Service
Note

N0001001

Model(s) Affected: 322 / 325 Series Trimmers

Subject: Broken Throttle Cable Levers

Figure A

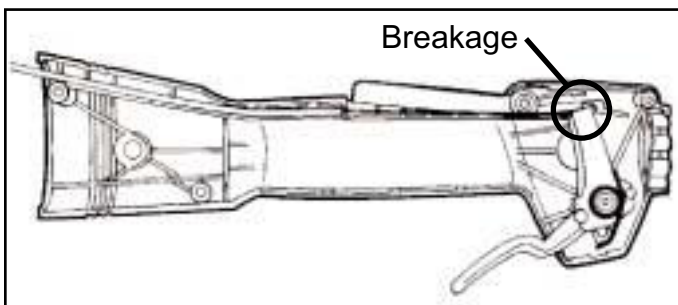
We have found that in some cases, the travel of the trigger is greater than the travel of the carburetor throttle valve.

If the operator continues to squeeze the trigger, the excess force causes the trigger lever to break (Figure A).

Figure B

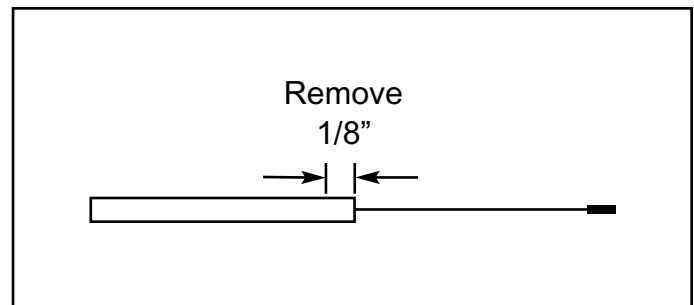
If you experience this problem, please perform the following modification in addition to replacing the broken trigger lever.

Remove 1/8" from the outer housing of the throttle cable at the trigger end (Figure B). This will allow for greater travel of the lever and prevent future breakage.
